ENGINE—6.8L—OIL LEVEL INDICATOR READS INACCURATE—SUPER DUTY F-53 MOTORHOME CHASSIS VEHICLES—UPDATED OIL LEVEL INDICATOR	Article No. 01-10-5

FORD: 1999-2001 SUPER DUTY F-53 STRIPPED CHAS.

Figure 1 - Article 01-10-5

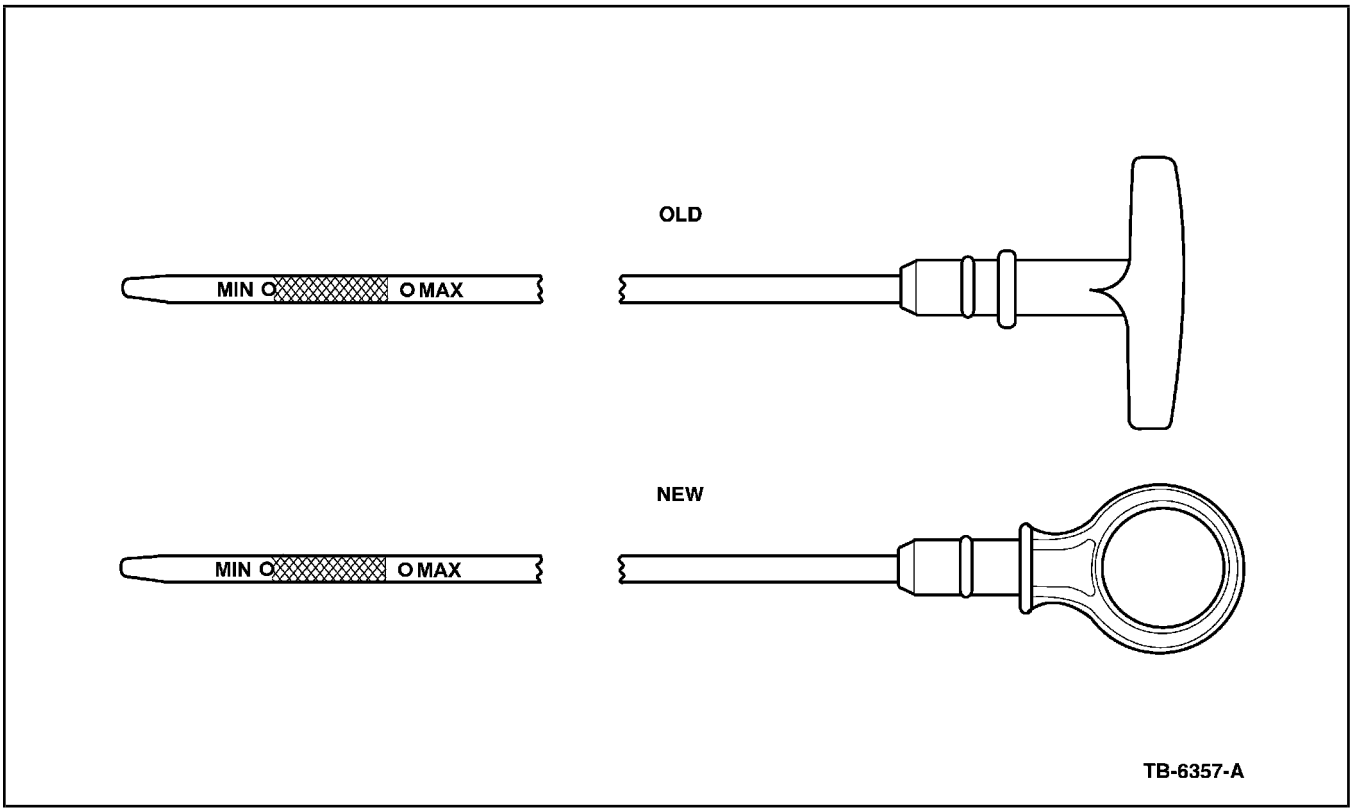
On some 6.8L equipped Super Duty F-53 Motorhome chassis vehicles, the oil level readings on the engine oil level indicator (dipstick) may read inaccurate (low) when the actual levels are within acceptable limits and adequate oil volume is in the sump. This may be noticed after an oil change, 5.7 L (6 quarts) of oil are added, and the engine has been started to fill the galleys and filter. The engine oil level indicator may then indicate 0.47 to 0.95 L (1/2 to 1 quart) low. This may be caused by the oil level indicator design.

Remove engine oil level indicator and replace with new design engine Oil Level Indicator (F81Z-6750-HC) which has correct markings to record oil levels at acceptable ranges. The new indicator has a “loop” handle. The prior indicator has a “Tee” stick-type handle (Figure 1).

PART NUMBER	PART NAME
F81Z-6750-HC	Indicator - Oil Level
